July 3<sup>rd</sup>, 2017

Comments on Portland Building – LU 17-153413 HRM AD

Dear Ms. Adam and members of the Portland Historic Landmarks Commission,

Please find attached additional materials pertaining to our argument against covering over the historic Portland Building in a metal façade. Attachments include:

### Illumination Levels (Lux) September 21, at 3pm

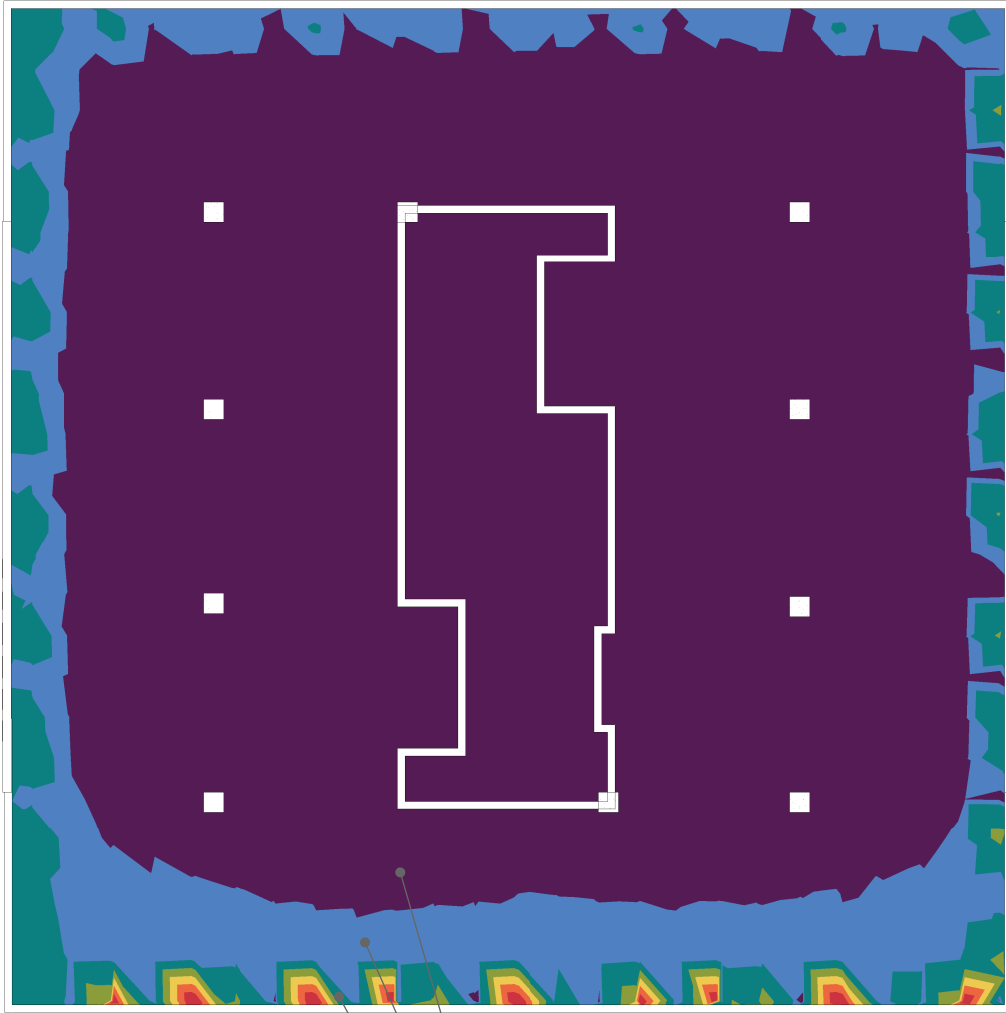
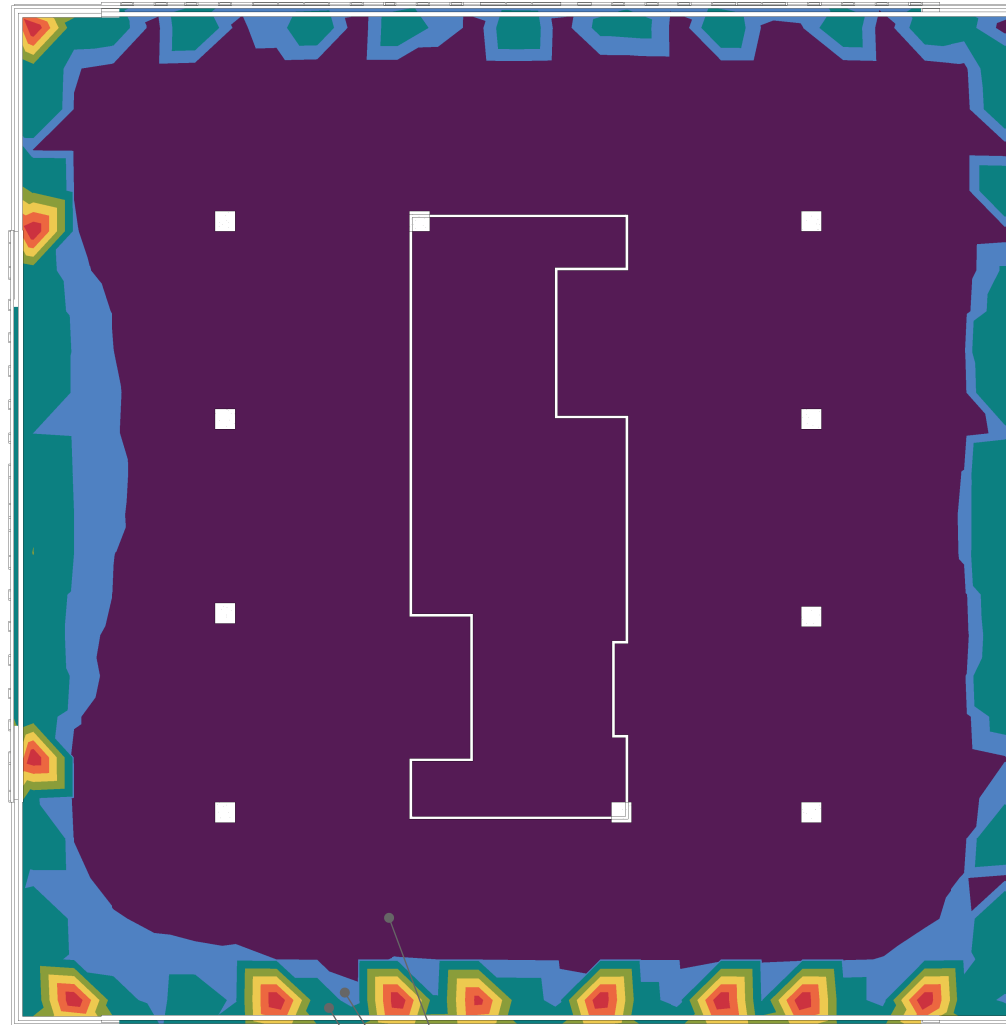
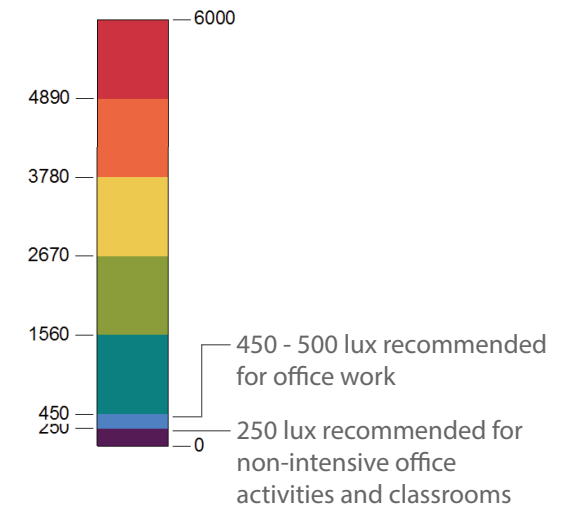
2. Two third-party cost estimates for proposed exterior façade vs renovation of façade.
3. Daylight study by Peter Meijer Architect, PC (PMA) showing the proposed project **does not** meet the proposed: *Project Goals & Values*, 4. *Quality workplaces c. Improved lighting including increased access to daylight. [D3 No. 06-2016 Phase 1 Report Acceptance]*
